January 15, 2001
PY-CEI/NRR-2538L

Perry Nuclear Power Plant
Docket No. 50-440
Supplement to a License Amendment Request Pursuant to 10CFR50.90:
Activation of Thermal-Hydraulic Stability Monitoring Instrumentation

3.3.1.3 Oscillation Power Range Monitor (OPRM) Instrumentation

Perry 105% Power Uprate Power/Flow Map (OPRM Armed Region)

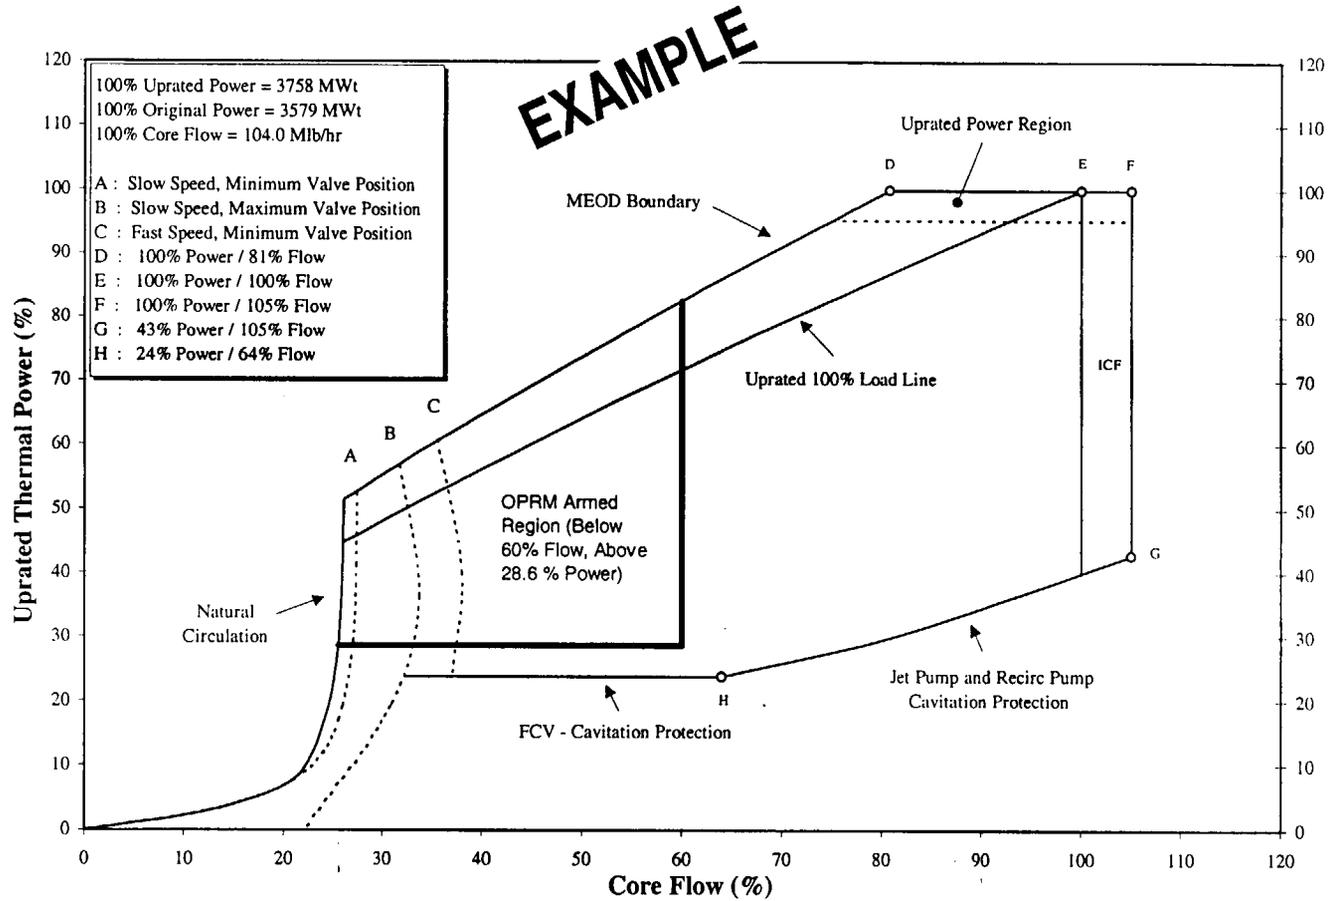
1. The Applicability, and Required Action C.1, are revised to reference 23.8% Rated Thermal Power (RTP) rather than 25% RTP.
2. The "power level" component of the Enabled (Armed) Region in Surveillance Requirement (SR) 3.3.1.3.5 is specified as 28.6% RTP rather than 30% RTP.

Attachment 4 provides an example Power/Flow Map showing this post-uprate OPRM Armed Region.
